Board of Public Works

SUBJECT: Consideration and possible action on updates to the 2020 General Conditions and Standard Specifications

RE: **Consider Updates to 2020 General Conditions and Standard Specifications**

2020 STANDARD SPECIFICATIONS

DRAWING NO:
C-6

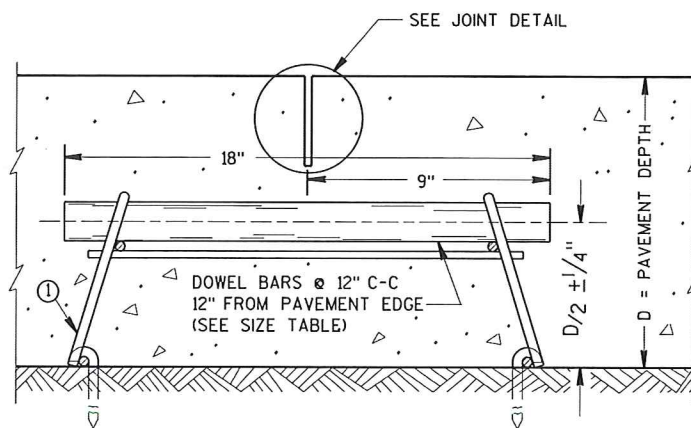
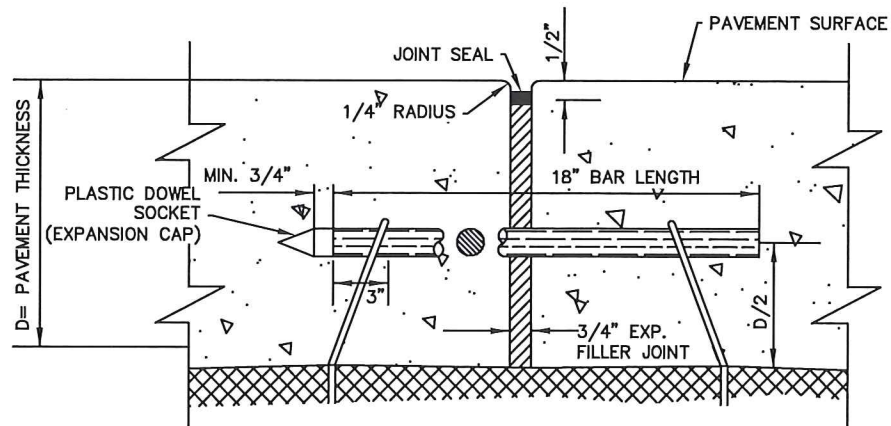
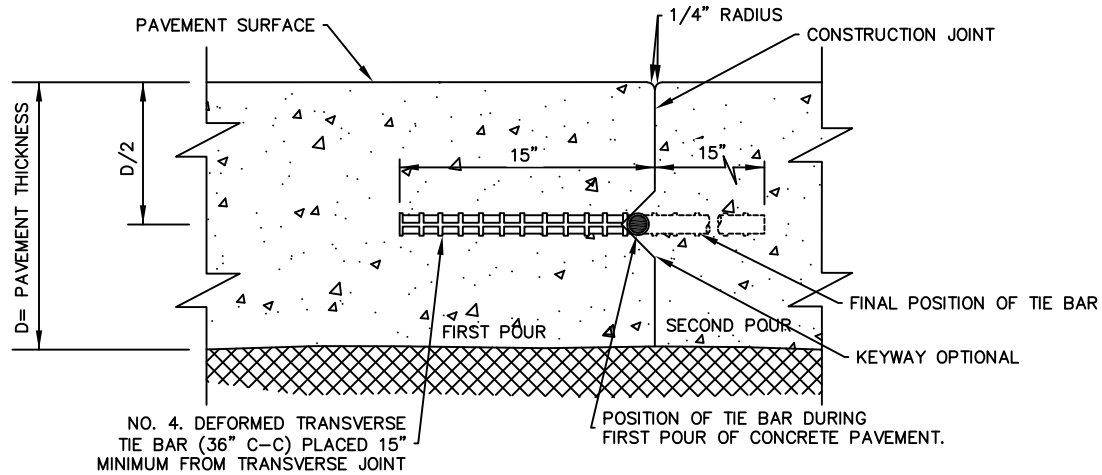
- 1) C-6 – Updated details to match WisDOT transverse joint details.
- 2) C-7 – Updated details to match WisDOT longitudinal joint details.
- 3) P-3 – Add the following notes:
 - "Notes:
 - 1. Install Reinforcement per Specifications."
- 4) S-7 – Updated detail to have services extended to the utility easement for new construction. Added the installation of 50 feet of coiled water service at end of the utility easement.
- 5) TW-2 – Updated the detail to show the 50 feet of coiled water service with tracer wire up to the utility easement for new construction.
